IN THE MATTER OF A PERMIT APPLICATION (AP-5873) FROM MEDICINE BOW FUEL & POWER, LLC TO CONSTRUCT AN UNDERGROUND COAL MINE AND INDUSTRIAL GASIFICATION AND LIQUEFACTION PLANT TO BE KNOWN AS THE MEDICINE BOW IGL PLANT

DECISION

Figure 1: Modeled Annual PM-10 Increment (% consumed)

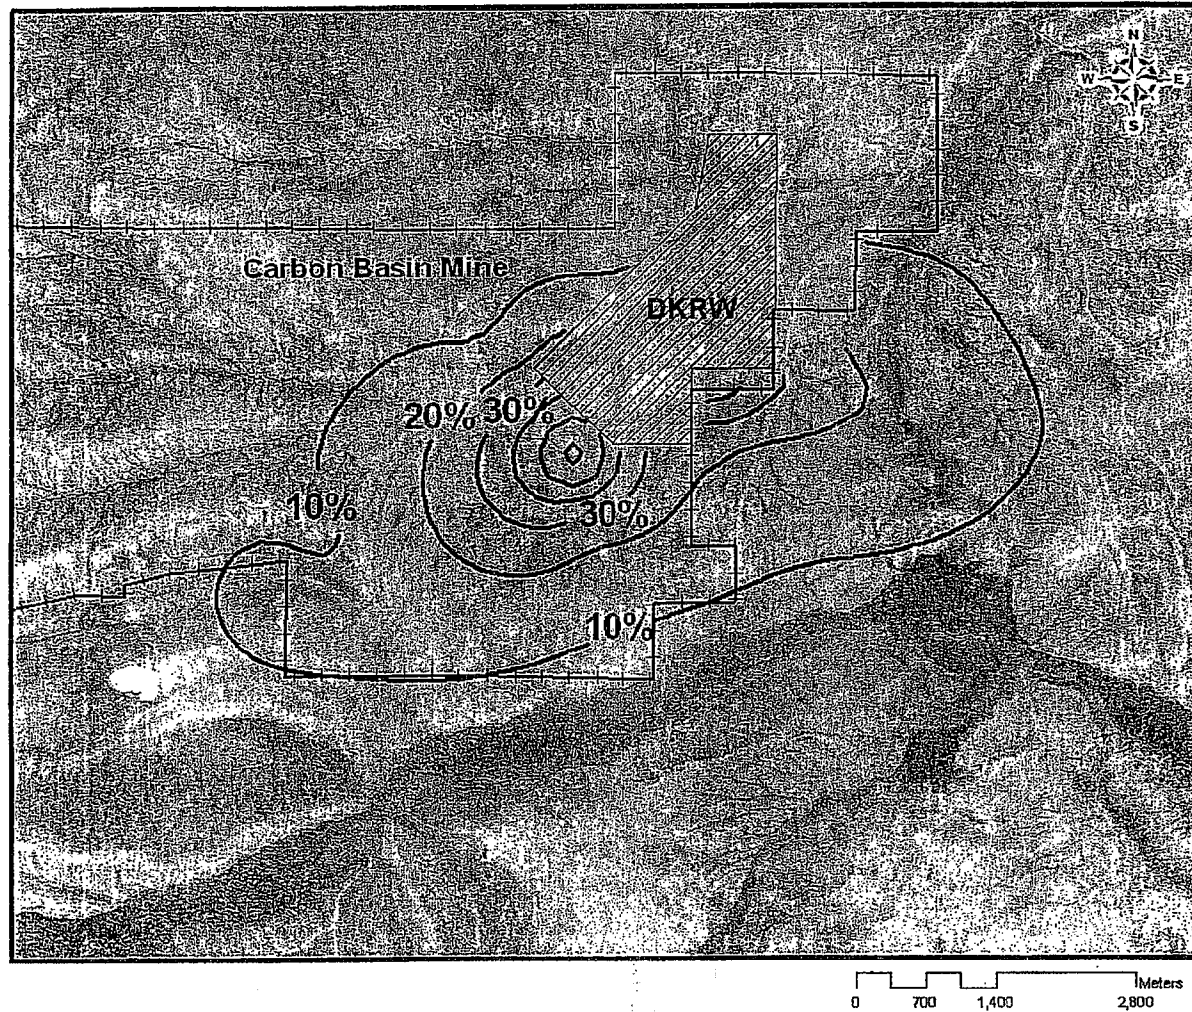
II.15 **Allowed particulate matter** – An individual commented that the plant will contribute up to 85% of the allowed particulate matter for the area, and raised several related questions:

Response – Emission controls for the project will consist of best available control technology (BACT). The Division's modeling analysis showed that 85% of the allowable PSD increment for PM₁₀ for the annual averaging period would be consumed near the proposed plant. The PSD increments are set at levels well below the NAAQS, and are designed to prevent newer sources from degrading the air quality in areas that attain the NAAQS. The area of relatively high increment consumption (> 50% of allowable level) is limited to an area on the western edge of the proposed facility boundary, which is contained within the boundary of the Carbon Basin Mine and not within the area considered "ambient" air available for public access. The extent of the modeled increment consumption is shown in Figure 1.

Response – The projected increment consumption was modeled with the proposed IGL plant sources and other nearby sources such as the neighboring coal mine, and therefore the current increment consumption (pre-IGL plant) was not considered. The results of the modeling indicate that the proposed facility will not prevent the attainment or maintenance of any air quality standard. The modeling domain did not extend to the Medicine Bow National Forest, which is located approximately 18 km to the southeast of the proposed project. The area of relatively high (> 50% of allowable level) increment consumption is predicted for an area at the west end of the boundary for the proposed project (see Figure 1).
